Application for Licence Amendment

Licence Number	L8578/2011/1
Licence Holder	Regis Resources Limited
ACN	009 174 761
File Number	2011/003002-1~2
Premises	Duketon Gold Project BANDYA WA 6440 Legal description – Mining tenements M38/114, M38/237, M38/250, M38/283, M38/292, M38/302, M38/303 M38/341, M38/343, M38/352, M38/354, M38/498, M38/499, M38/500, M38/589, M38/630, M38/943, M38/1091, M38/1249, M38/1250, M38/1251, M38/1257, M38/1259, M38/1260, M38/1261, M38/1262, M38/1263, M38/1277, L38/201, L38/202, L38/203, L38/204 and L38/216. As defined by the Premises maps attached to the Revised Licence
Date of Report	17 December 2021
Decision	Revised licence granted

Licence L8578/2011/1 is held by Regis Resources Limited (Licence Holder) for the Duketon Gold Project (the Premises), located on the mining tenements defined in the licence. Prior to this amendment, L8578/2011/1 only covered the Garden Well premises, including Rosemont Gold Mine. Moolart Well premises (located immediately to the north) operated under a separate licence, L8412/2010/2, which the Licence Holder has applied to surrender concurrent with this amendment application. Garden Well and Moolart Well are now run as a singl

Figure 1: Location of dewatering discharge pits at Garden Well (RMT pit and Erlinstoun Pit).

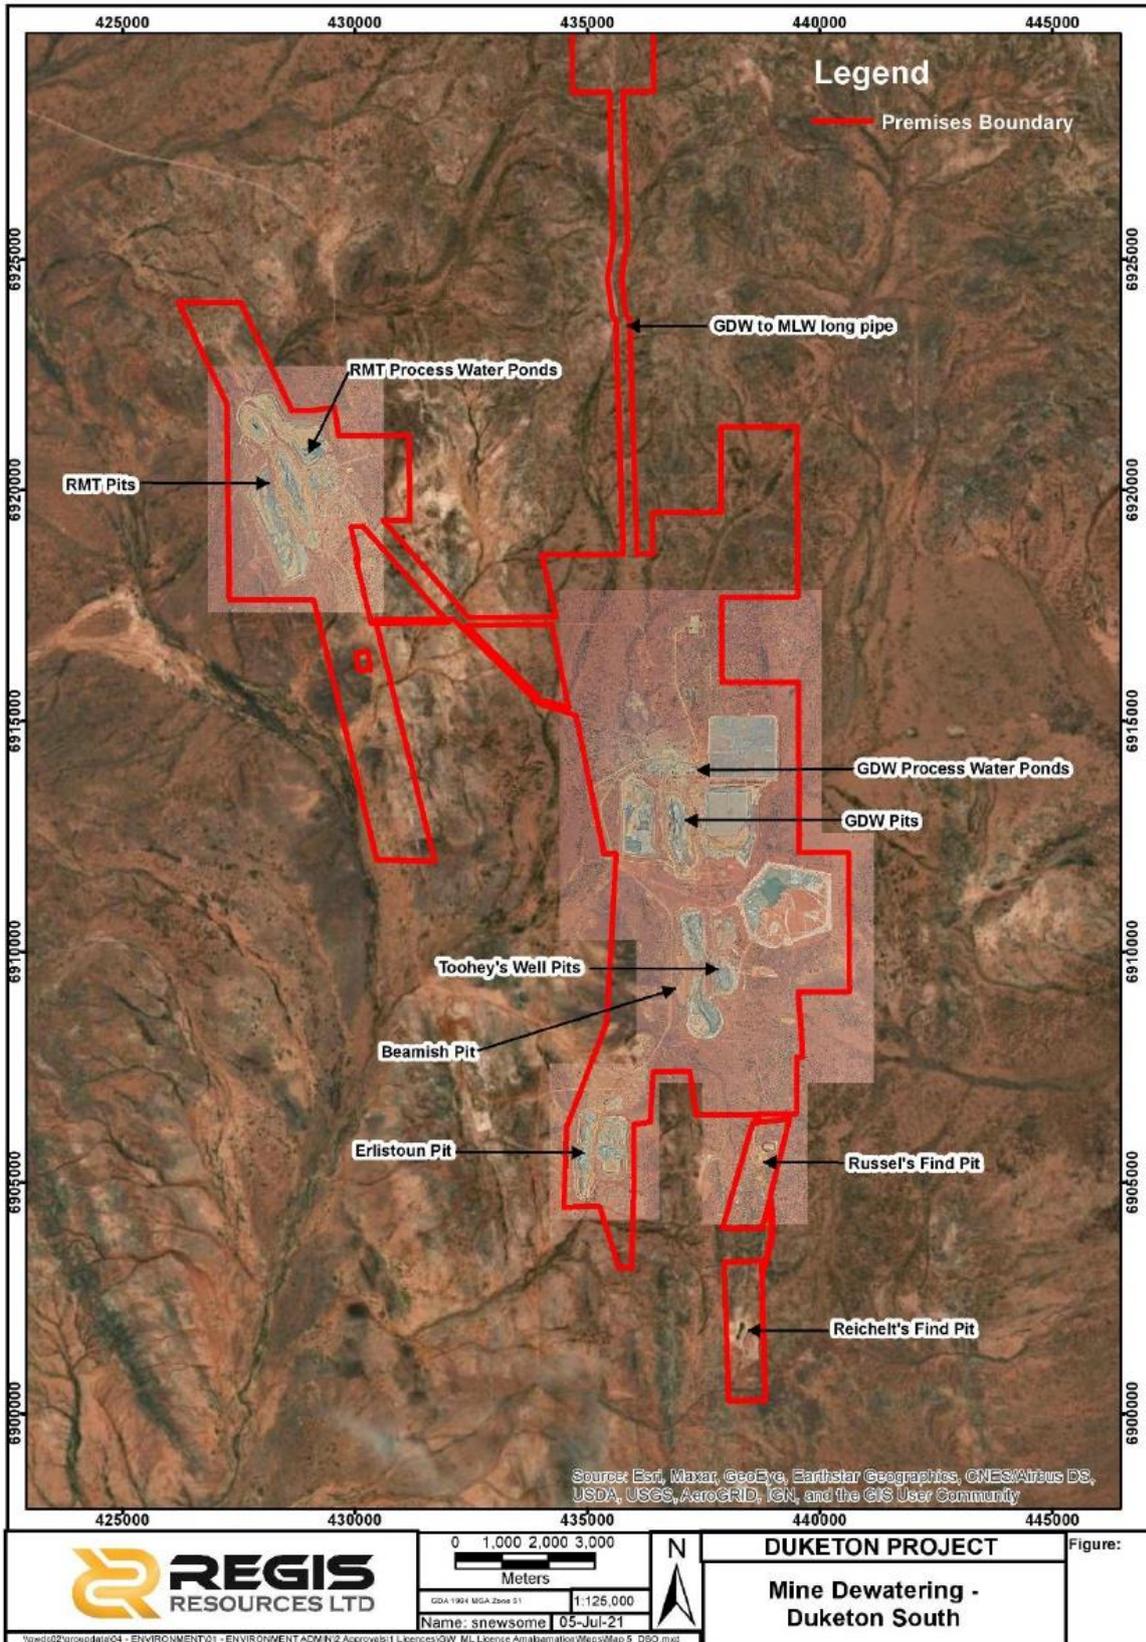
The location of Eristoun pit is shown in Figure 1, along with existing dewatering discharge location at Rosemont (RMT) pit. Construction of dewatering pipelines to Reichelt's Find and Russell's Find was approved in W5113/2011/1, however these were not constructed, and the works approval has now expired. If the Licence Holder wishes to construct these pipelines in the future, a new works approval will need to be applied for.

Total dissolved solids (TDS), pH and metals data has been provided from bores near Eristoun Pit, Garden Well Pit and Baneygo Pit. Groundwater around the Eristoun Pit has a salinity ranging from approximately 22,000 mg/L to 27,000 mg/L, which is too saline for most livestock and wildlife. Most mine dewater discharged to Eristoun will be from Garden Well Underground with TDS between 1,000 mg/L and 11,000 mg/L, which is brackish to saline. Minor inflow may also come from Baneygo Pit, which is more saline ranging between 60,000 mg/L and 77,000 mg/L TDS. However, this will be in very small quantities during wet weather when dust suppression is not required. Evaporation will tend to raise the salinity of the Eristoun pit lake over time, while water inflows from Garden Well are likely to lower it. Detailed modelling would be required to predict the actual salinity over time, and the impact of subsequent groundwater mounding. The Delegated Officer considers this is not required given that the groundwater in the area is all brackish to highly saline, with no identified beneficial uses apart from mining. A condition will be placed on the licence specifying a minimum pit freeboard of 4m, which is expected to keep groundwater mounding outside the root zone of surrounding vegetation.

As the Licence Holder has provided no calculations showing the anticipated maximum level in Eristoun Pit or proposed freeboard, it is **Possible** that **Moderate** impacts to vegetation could occur in the event of saline groundwater mounding into the vegetation root zone. This results in a risk rating of **Medium**. A limit will be required to specify a maximum standing water level of 4m below pit crest for Eristoun Pit.
